Title: Advisory Committee on Reactor Safeguards
 APR1400 Subcommittee Meeting

Date: Friday, May 19, 2017

Chapter 15: Transient and Accident Analyses

□ Description of LBLOCA (cont'd)

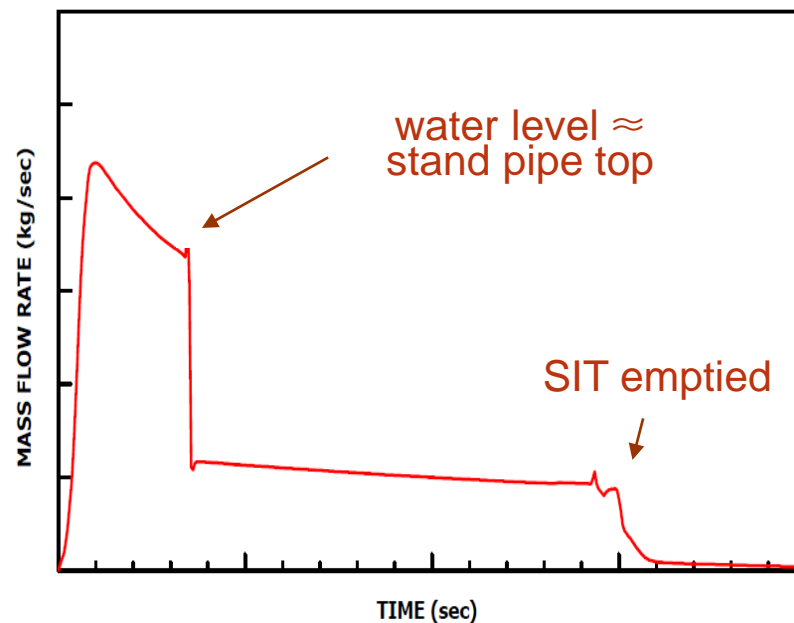
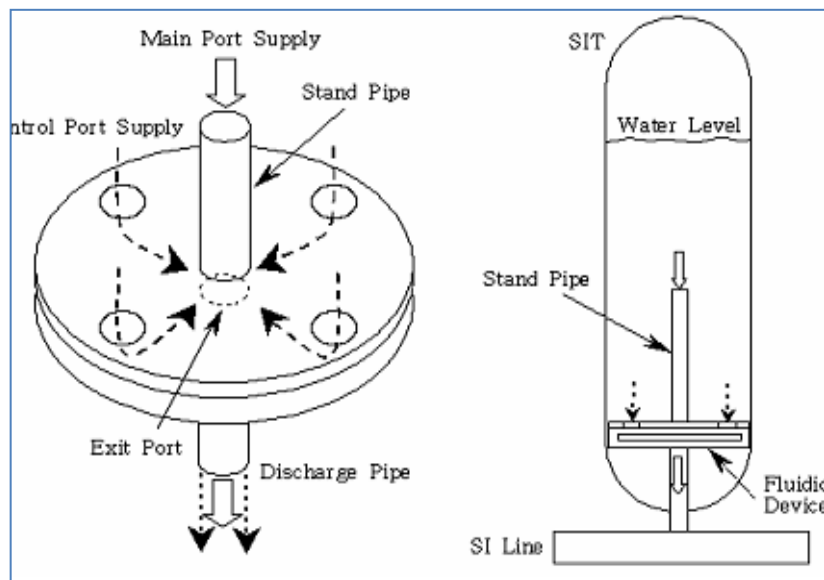
22 MEMBER MARCH-LEUBA: While you have the
23 figure, this is Jose. While you have the figure, later
24 on the loop seal clearing, we're going to be concerned
25 about bypass flows between the upper plenum and the

2 There is a seal, metal seal, on the top
3 upper plenum that we were told, that is assumed,
4 (unintelligible) with three percent bypass flow, but is
5 expected to be less than one. Can you point where it
6 is in the figure, right there?

7 MR. CHON: It's not clear in this figure,
8 but there is some gap between the top upper plenum,
9 downcomer region.

□ Post LOCA LTC Results

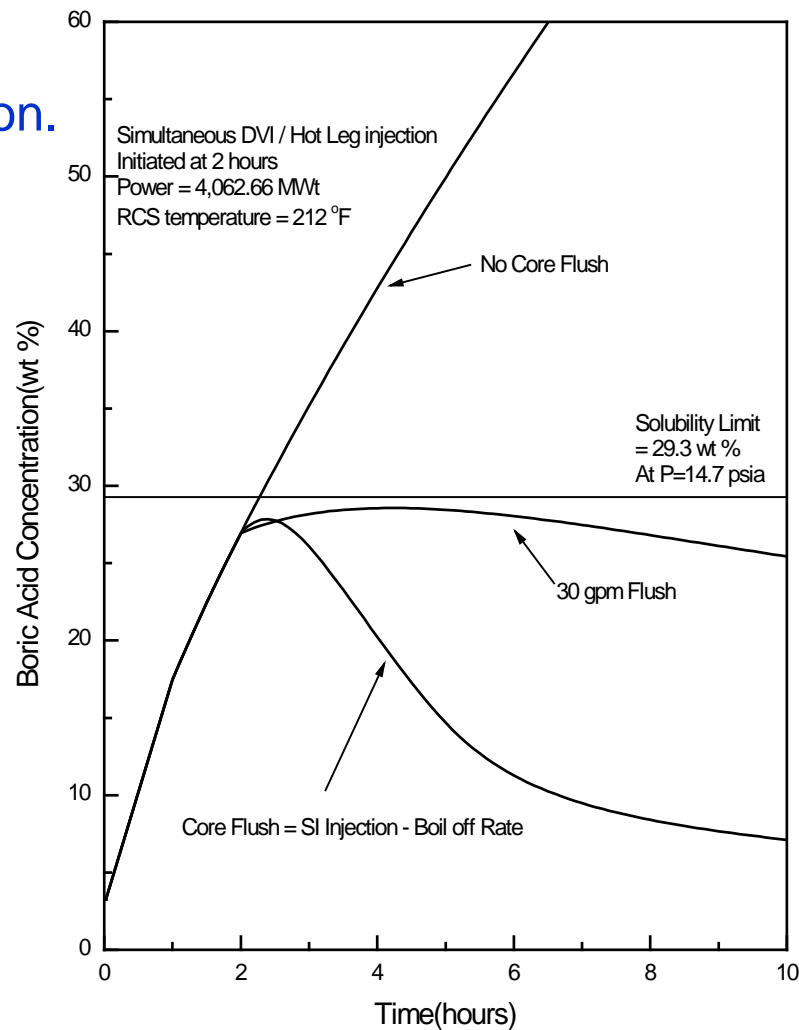
16 First one is no core flush. If you see the
17 right hand side of the figure the temperatures boric
18 acid concentrations. The right line is no core flush.
19 The straight line at the middle is solubility limit.

Pressure drops vs. particle to fiber ratio

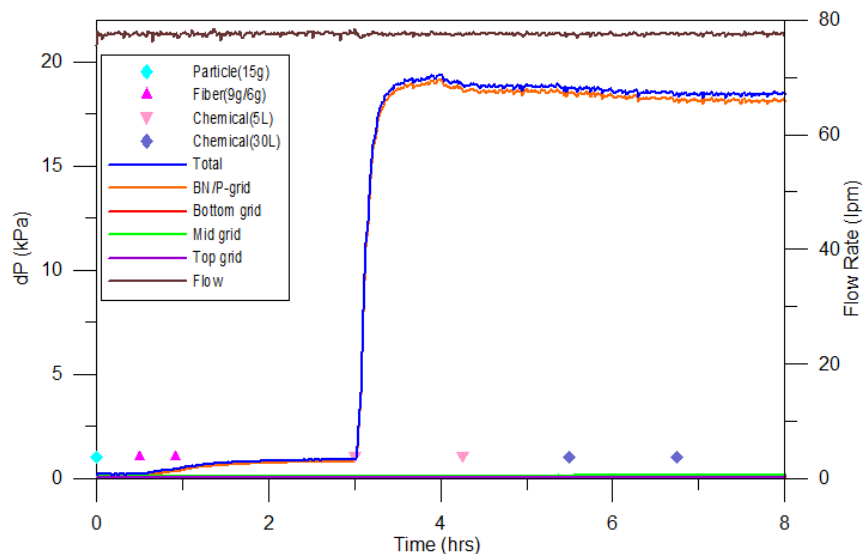
15 MEMBER SCHULTZ: So the change was, seems
16 more dramatic in the hot leg break in the low range of
17 particle to fiber ratio and in the cold leg break across
18 the spectrum of particle to fiber ratio there is some
19 change but not dramatic. Is that a good summary, a fair
20 summary?
